ARKANSAS NUCLEAR ONE, UNIT 1

Amendment No. 82
License No. DPR-51

ARKANSAS NUCLEAR ONE, UNIT 2

Amendment No. 52
License No. NPF-6

Figure 6.2-1 Management Organization Chart

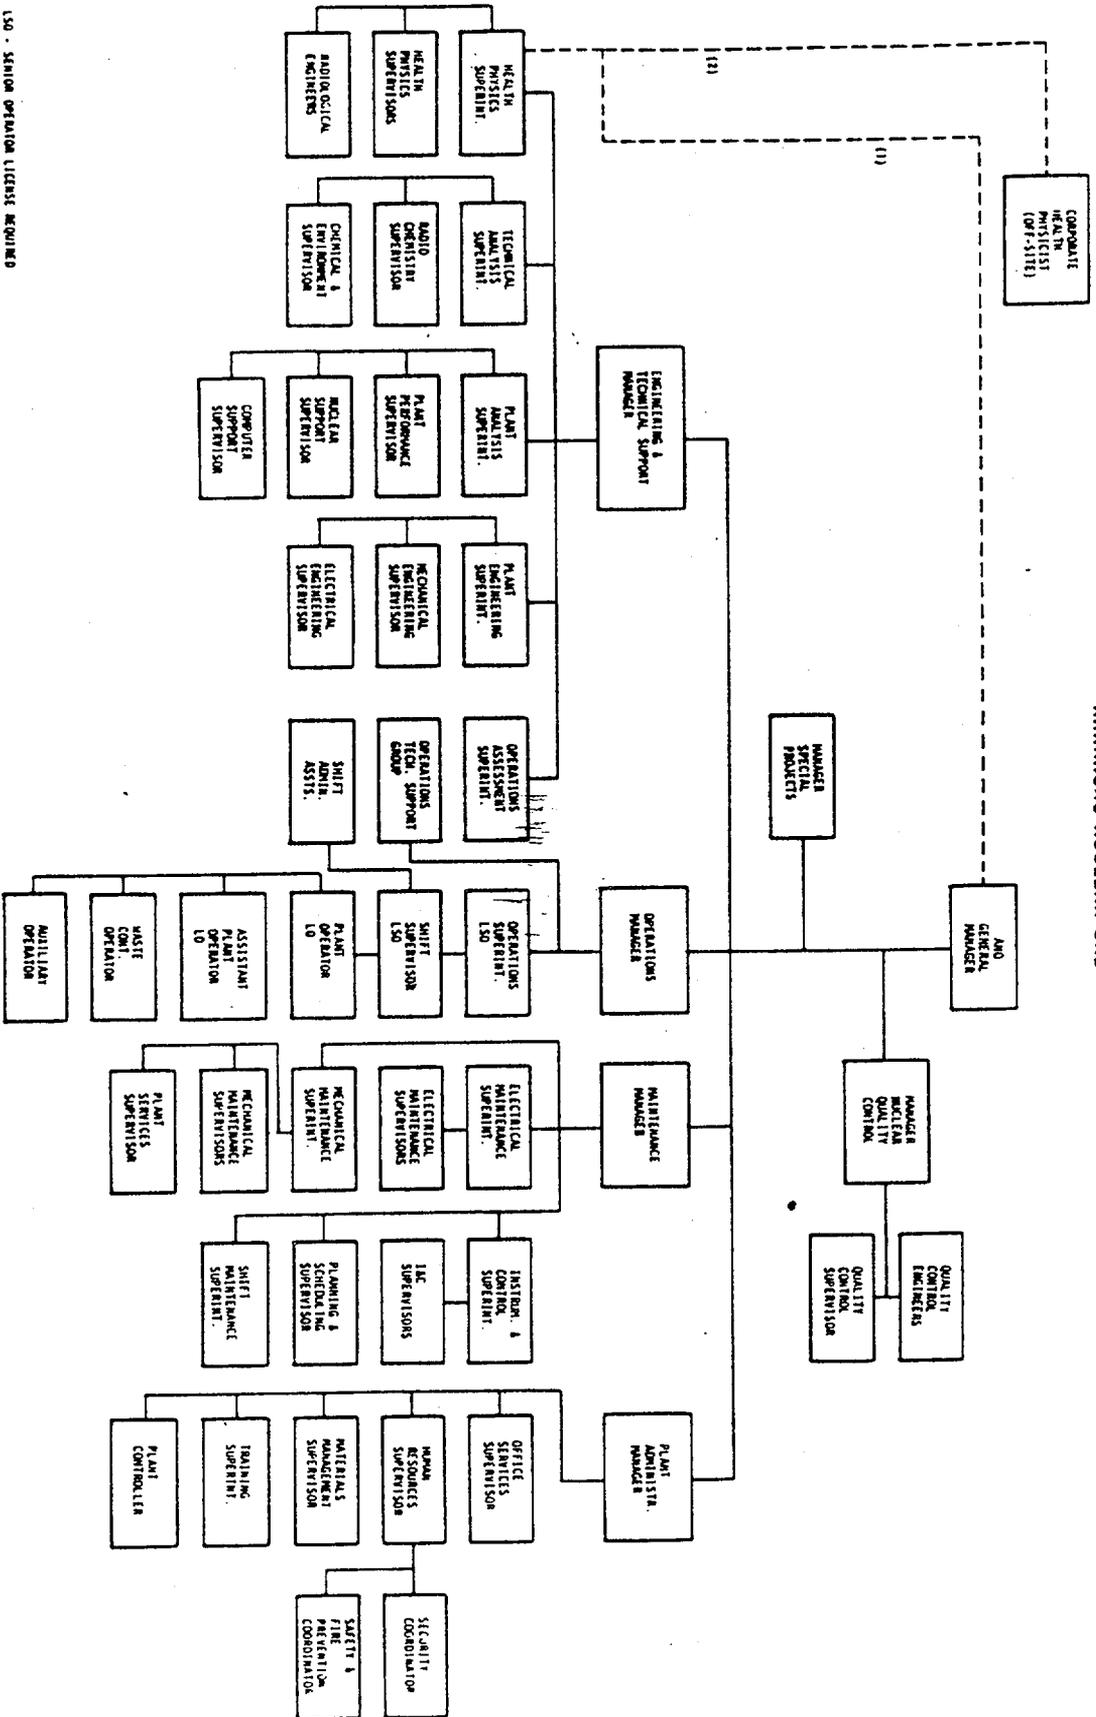
These amendments revise the Technical Specifications (TS) to reflect a reorganization of the Energy Supply Department of Arkansas Power & Light Company (AP&L) and the position title change of the Assistant Vice President, Nuclear Operations, to the Vice President, Nuclear Operations. The reorganization has resulted in changes in the membership of the AP&L Safety Review Committee (SRC). However, the effectiveness of the independent review and audit function of the SRC would not be reduced as a result of the change in membership of the SRC in that the appropriate technical disciplines necessary for the noted function would still be represented in the new make-up of the SRC. In addition, the SRC would report to the Vice President, Nuclear Operations, since he has been designated as the AP&L Senior Nuclear Management Representative.

(1) The Energy Supply Senior Vice President is on a temporary leave of absence from AP&L, serving as the Senior Vice President of Nuclear Operations for Louisiana Power and Light Company. During this absence, Mr. J. B. Phillips, Senior Vice President will assume senior management of the Energy Supply Department reporting directly to the President and Chief Executive Officer.

(2) In the absence of the Energy Supply Senior Vice President, the Nuclear Operations Vice President will report directly to the President and Chief Executive Officer.

Figure 6.2-1 Management Organization Chart

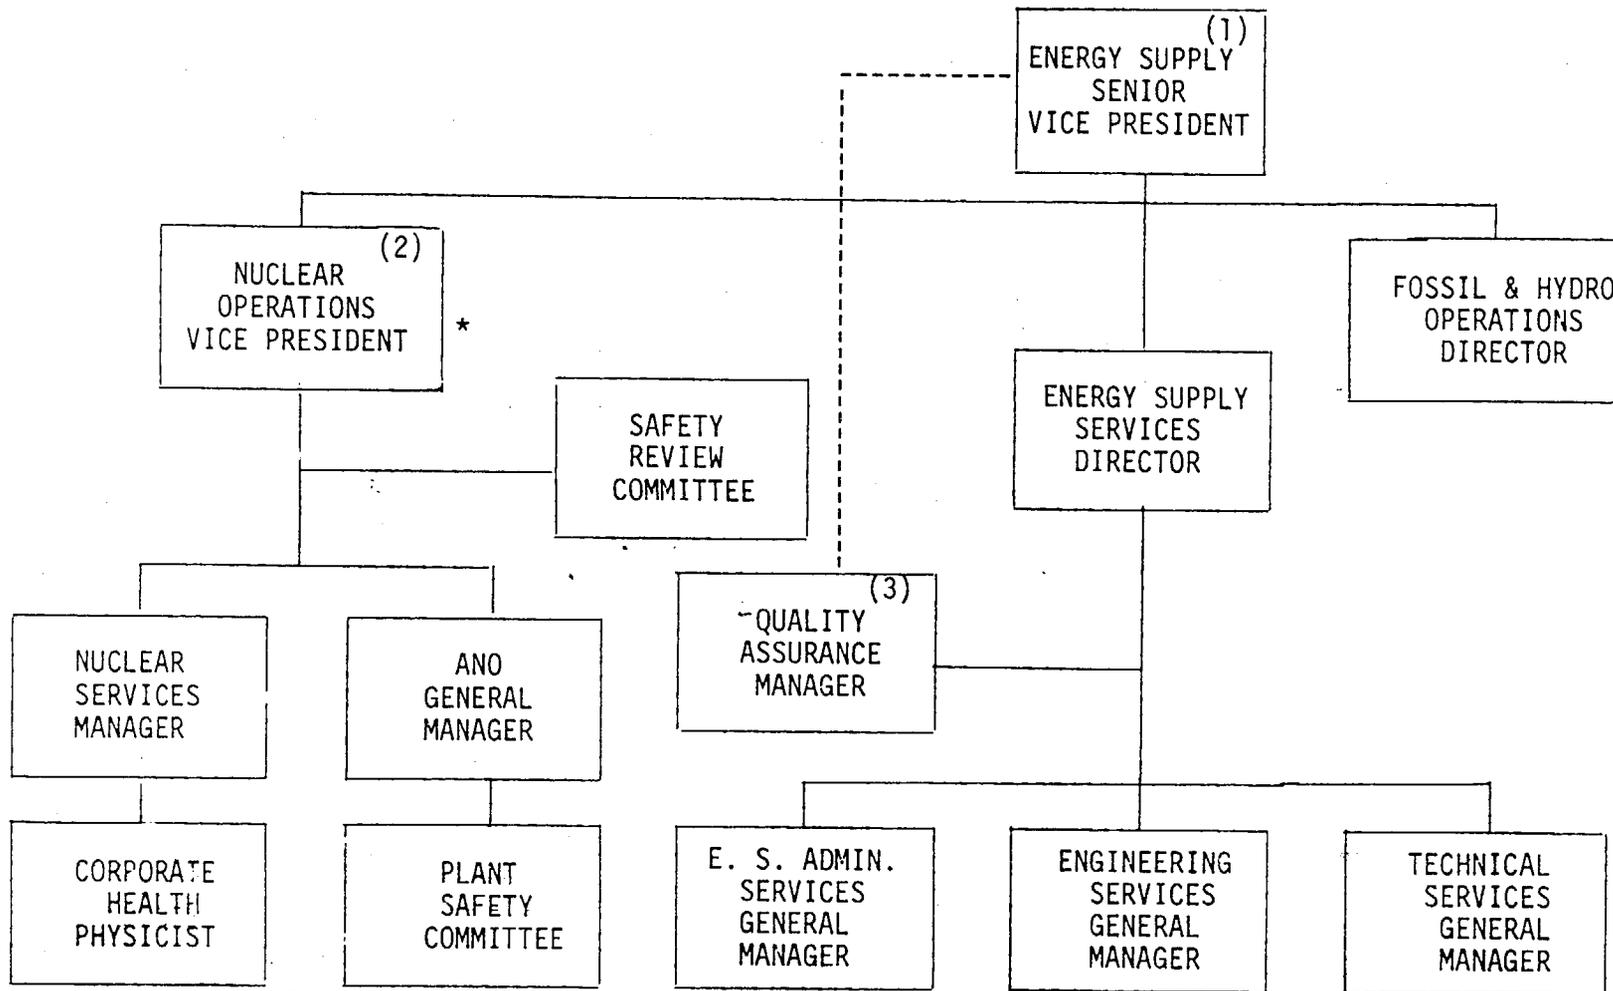
- (1) The Energy Supply Senior Vice President is on a temporary leave of absence from AP&L, serving as the Senior Vice President of Nuclear Operations for Louisiana Power and Light Company. During this absence, Mr. J. D. Phillips, Senior Vice President will assume senior management of the Energy Supply Department reporting directly to the President and Chief Executive Officer.
- (2) In the absence of the Energy Supply Senior Vice President, the Nuclear Operations Vice President will report directly to the President and Chief Executive Officer.
- (3) The Quality Assurance Manager will report (dashed line function) to the Vice President, Nuclear Operations during the absence of the Energy Supply Senior Vice President.

FIGURE 6.2-2 FUNCTIONAL ORGANIZATION FOR PLANT OPERATION

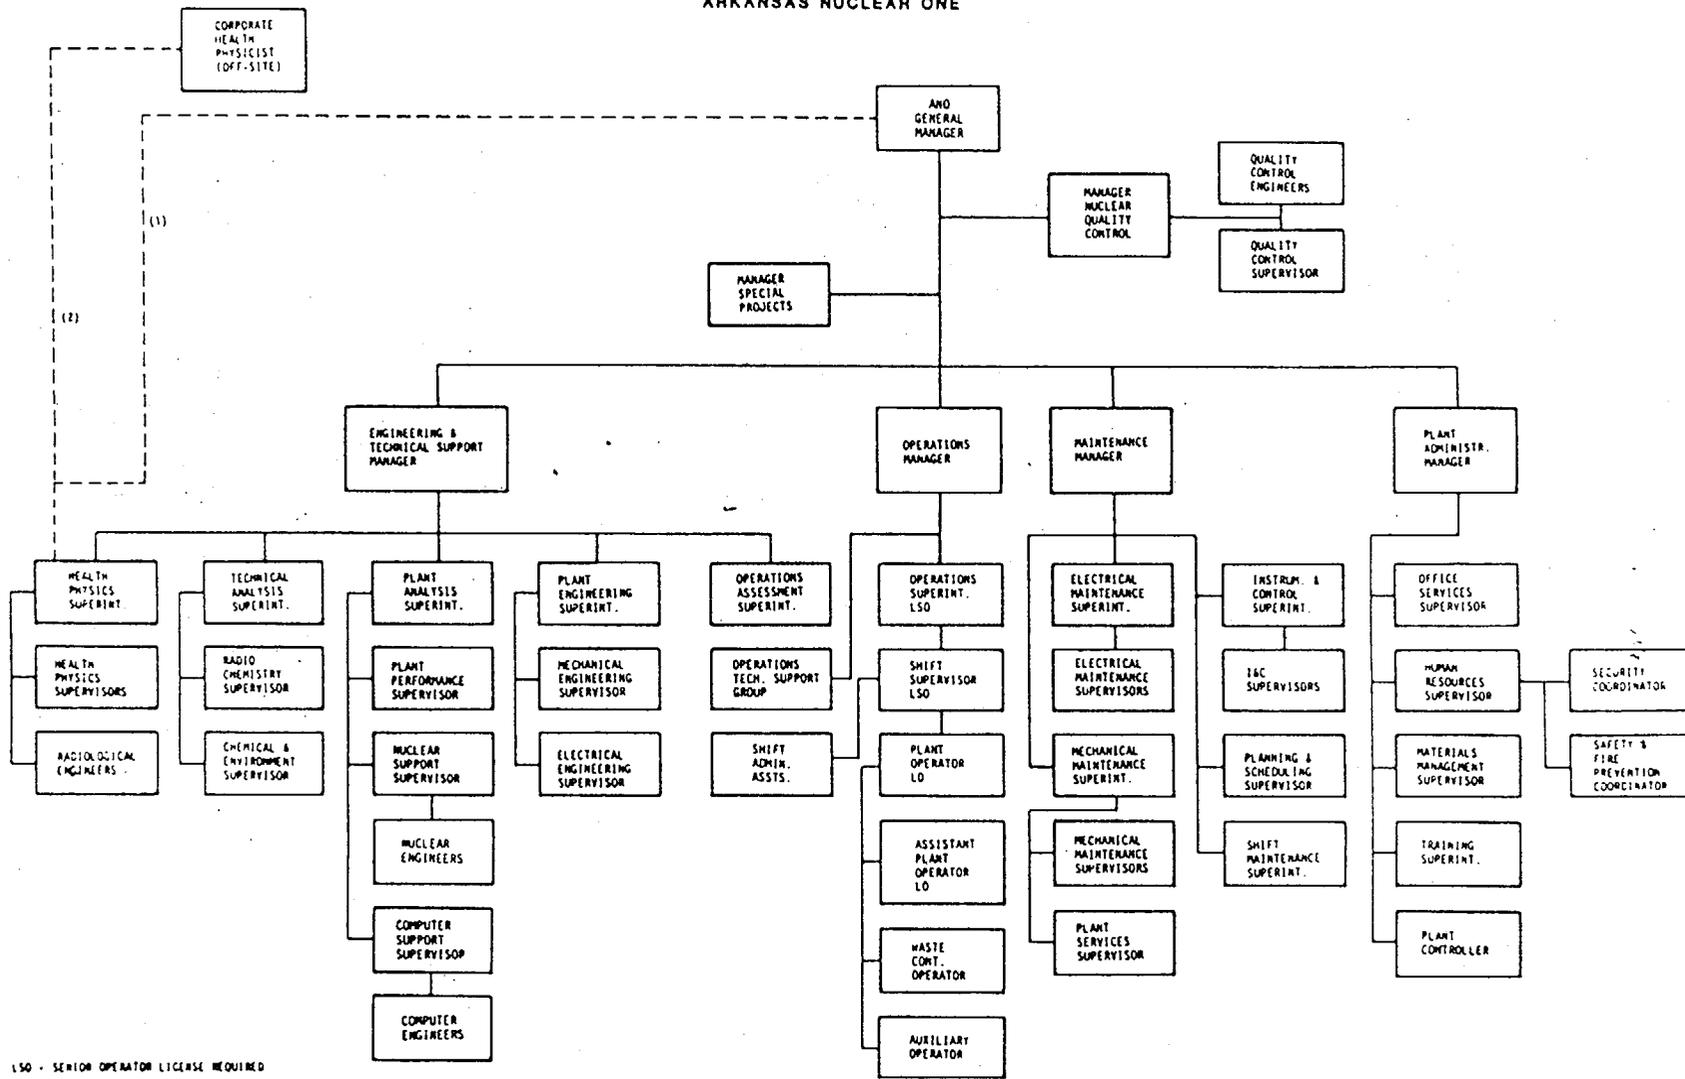
The amendments also revise the Technical Specifications to reflect a reorganization of the ANO-1&2 plant functional organization. The reorganization includes a realignment of existing functions within the plant operations staff and the addition of a technical support group, a shift administrative assistant, a shift maintenance superintendent and a training superintendent to the plant operations staff.

(1) The Health Physics Superintendant reports to the Manager, Engineering and Technical Support in administrative matters and routine health physics concerns and he reports to the General Manager in matters of radiological health, safety and policy.

(2) The Health Physics Superintendant has direct interface with the Corporate Health Physicist in matters of radiological health and safety. The Corporate Health Physicist reports to the Manager, Nuclear Services. He will help formulate Corporate Health Physics Policy and ensure that it is properly implemented.
